"CRC" 33MM-400 CAP			
MOLD-RITE PLASTICS INC. PLATTSBURGH, NEW YORK			
TOLERANCE: +/- .010	DRAWN BY:	P.D.T.	
SCALE: FULL	DATE: 7-5-95	DRAWING NO.	C-8018

SUBJECT: CRC-33-400 CAP ASSEMBLED

**DRAWING REVISION PAGE**

**DOC: C-8018**

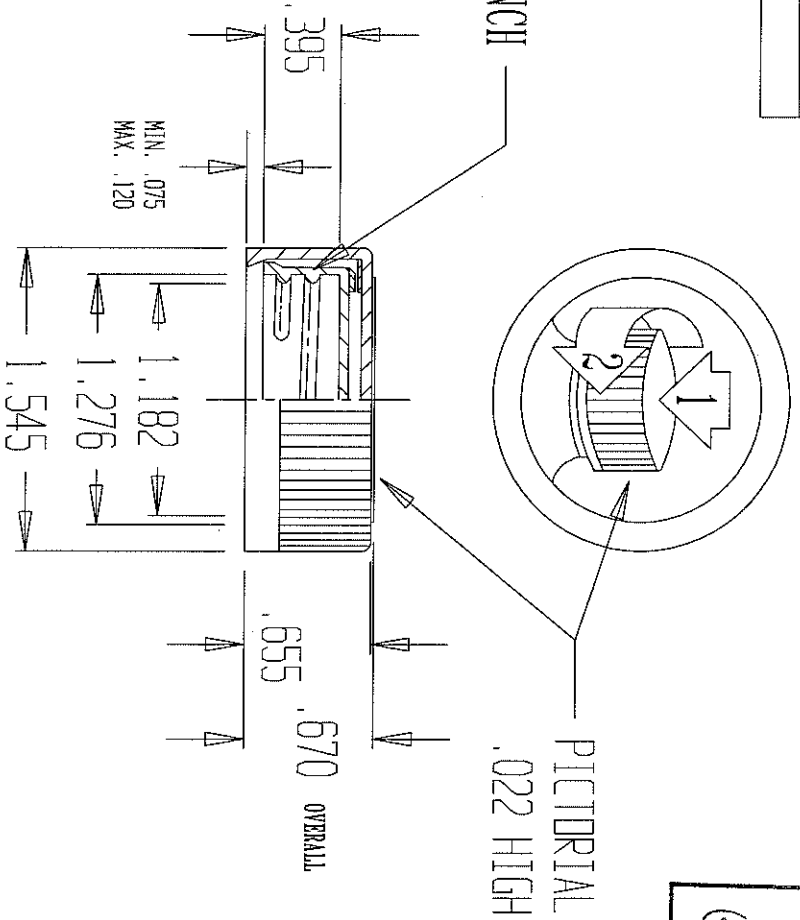
REVISIONS			
REV.	DATE	APPROVAL	DESCRIPTION
1	06/28/01	G.C.	ADDED THREAD PER INCH
2	04/05/05	G.C.	B DIM. TO .670

REV LEVEL	REV DATE	DESCRIPTION OF CHANGE
2	April 5, 2005	Historical data indicates outer "B" dimension has consistently measured at about .670 inches. Updating drawing to reflect actual measurements. Changed B=.677 to .670. No tool change was done.

"I"	"E"	"H"	"A"	"B"
1.276	1.182	.395	1.545	.670
